CITY OF SHEBOYGAN

REQUEST FOR ARCHITECTURAL REVIEW BOARD CONSIDERATION

ITEM DESCRIPTION: Construction of new Popeyes Restaurant at 3207 S. Business Drive.

ITEM DESCRIPTION: Exterior Remodel of Verlo tenant space in the multi-tenant facility located at 4315 S. Taylor Drive.

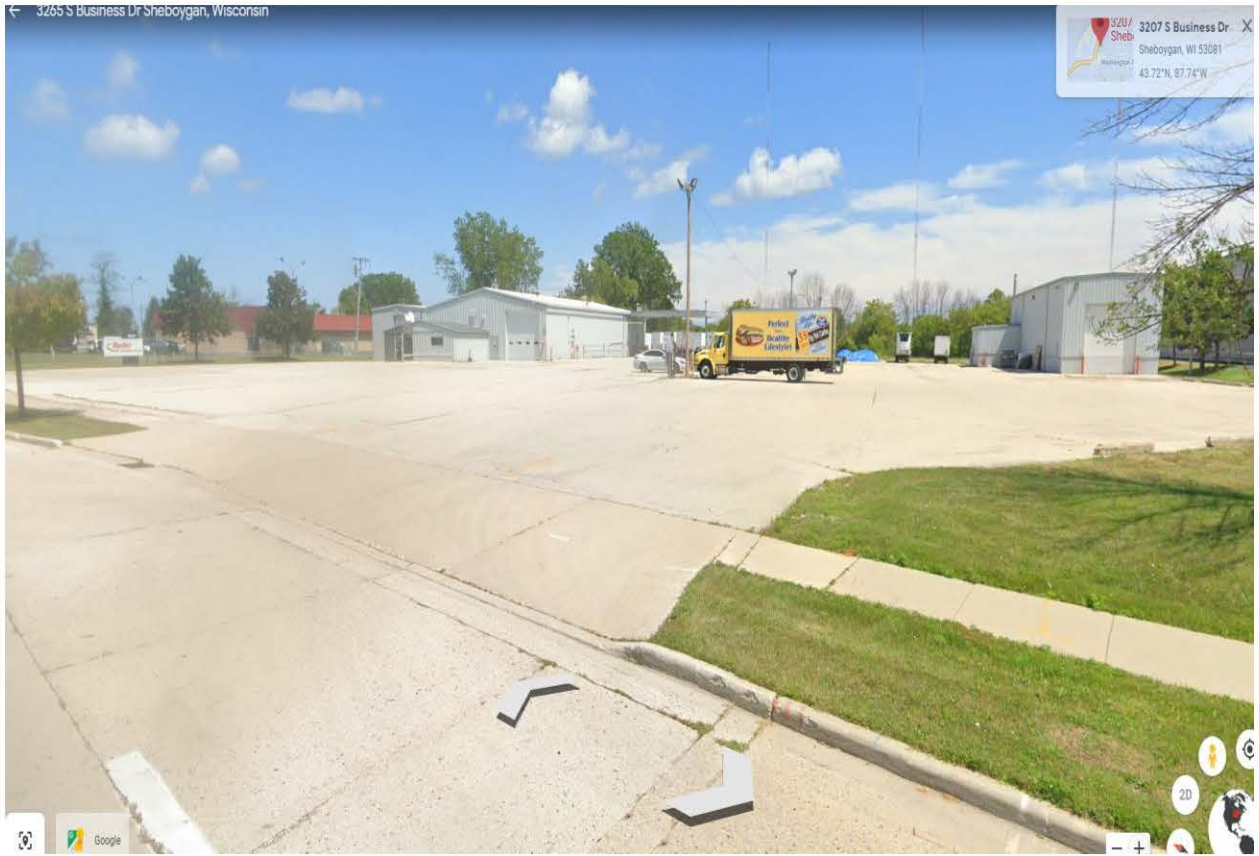
The Board should have the applicant explain the reasoning behind this design. Staff is unsure about the fiber cement vertical wood siding (Nichia) on the main tower element below the proposed EIFS. Should the same horizontal design be used so the building is uniform? Should there be more brick instead of EIFS on this front/S. Business Drive building elevation to be more consistent with the other outlots developed in this area? Does the board feel comfortable with the front elevation?

- The shutters on both north and south sides of the rear of the building are teal in color. Is there a reason why the shutters cannot be similar in color to that of the trim and/or awning colors located on the building (similar to the other Popeyes Brand Orange and Red accents on the building)?
- Any thoughts on the freezer design - Freezer just looks like it is placed at the back of the building with a design that does not relate to the rest of the building.
- There are several horizontal band elements that just seem to dead end – is there a reason why these bands could not extend throughout the sides of the building?
- Is there any reason why the brick on the “Main Entry” south elevation (love that chicken) could not be stepped up above the EIFS portions of the building similar to the building design on the “drive thru” north elevation?
- Will the parapet cover the mechanicals?

Sketch on 4315 S Taylor Drive

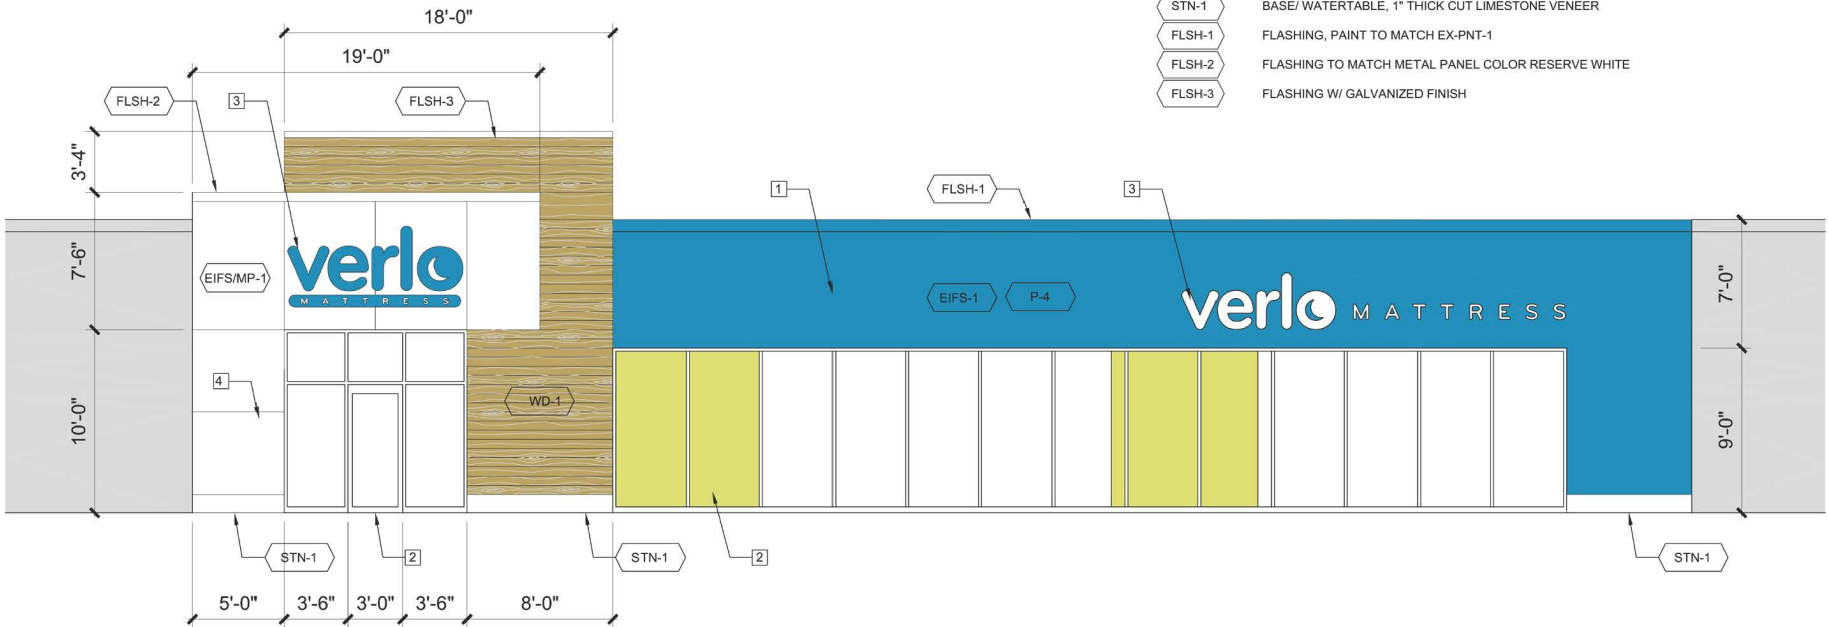
- It is unlikely the Board will accept the conceptual plans/drawings you have provided for such an exterior remodel project because this does not show the specific details to this tenant space and how it impacts the rest of this building.
- As a stand-alone entry on a standalone building, there might not be any issues with this design. However, this design impacts the architecture of the rest of the building which could impact neighboring tenants. The Board will want to see a scale elevation drawing of the Verlo tenant space as well as the rest surrounding building to see how this all works together. What is the impact this façade renovation is having on the rest of the building? Typically, buildings are completely remodeled and not just one (1) tenant space in a multi-tenant facility.

- The arches at the paired entries are pushing to identify/consolidate the entrances, and this overlay of an entry façade seems to be ignoring the overall building's architecture.
- Inserting a very foreign-seeming element that doesn't seem to relate to its context (especially with the stepped parapet line).
- Difficult to understand the various projections and how they're impacting the building lighting and what's happening to the next window to the south?

- A nice simple sign might be much easier - if you just leave the building alone and add signage that would work.
- Does this need to be so elaborate? If so, then you will need to work with an architect to plan it properly (or at the very least a Verlo corporate designer).
